NEW ELEMENTARY SCHOOL
9801 HIGHLAND KNOLLS DR
BAKERSFIELD
CALIFORNIA
93306

NEW MIDDLE SCHOOL
4115 VINELAND ROAD
BAKERSFIELD
CALIFORNIA
93306

SHEET TITLE
**FIRE ALARM PLAN
BUILDING D**

E-131D
SHEET OF

FIRE ALARM PLAN BUILDING D

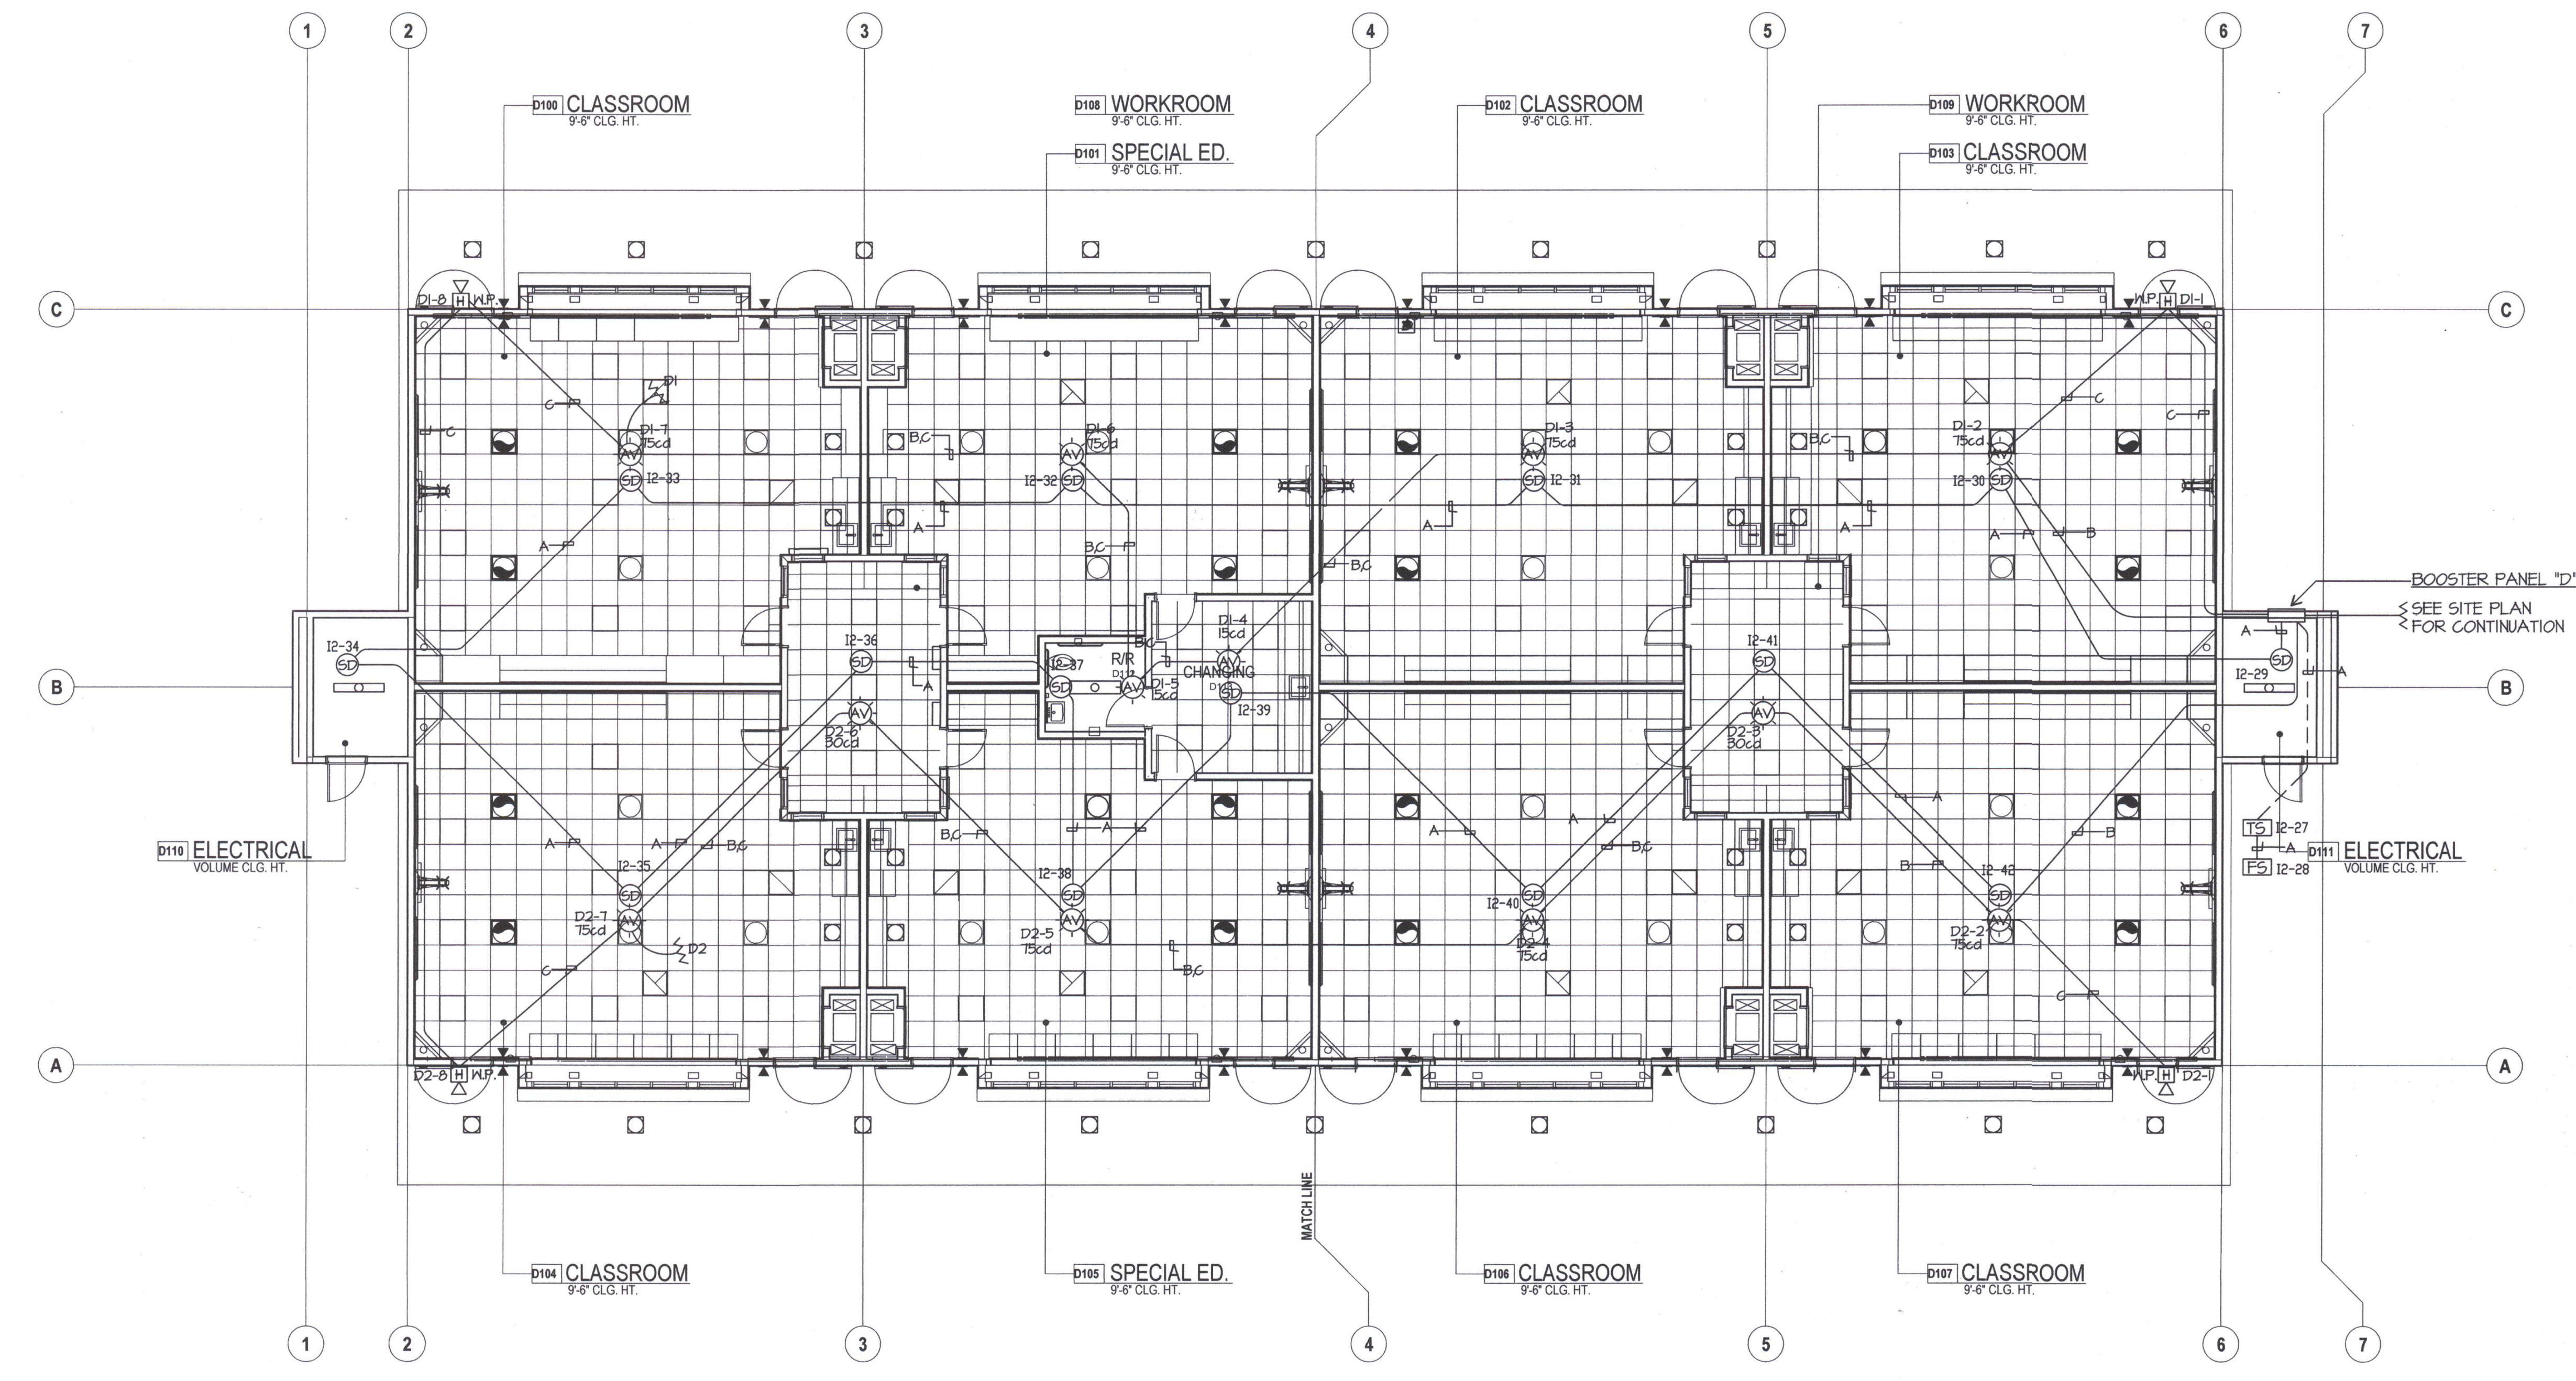
Tomhawk Builders - 517713
Reflected Ceiling Plans at Buildings D & G Classrooms do not show the same Suspended Ceiling quantities as that which are shown on Electrical Drawings Sheet E-1310 and E-1302. Our Schedule submitted was based on the design criteria shown on the Reflected Ceiling Plans. Please advise.

Joe Covington - OMA - 517713
After review of Architectural Plans it has been determined that the Buildings D and G refer to one Classroom in Building D100 as "TYPICAL MIDDLE SCHOOL" classroom.
The Reflected ceiling plan for this one classroom indicates the diameter provided for the skylights as required for the "TYPICAL MIDDLE SCHOOL" classroom.
Whether or not they are shown on other reflected ceiling plans should have raised the question prior to bid.
The fact that the Electrical documents indicate the required electrical connections to be provided for all the locations considered TYPICAL should also have raised the question concerning which skylights are provided with diameters since all documents are to be reviewed and coordinated prior to bid.
We stand by our decision that all Classrooms, both Elementary and Middle have been designed with the exact same layout and amenities, and no statements providing direction of DISCREPANCIES were provided for their use.

Any questions regarding discrepancies or requests for clarification should have been submitted prior to bid.
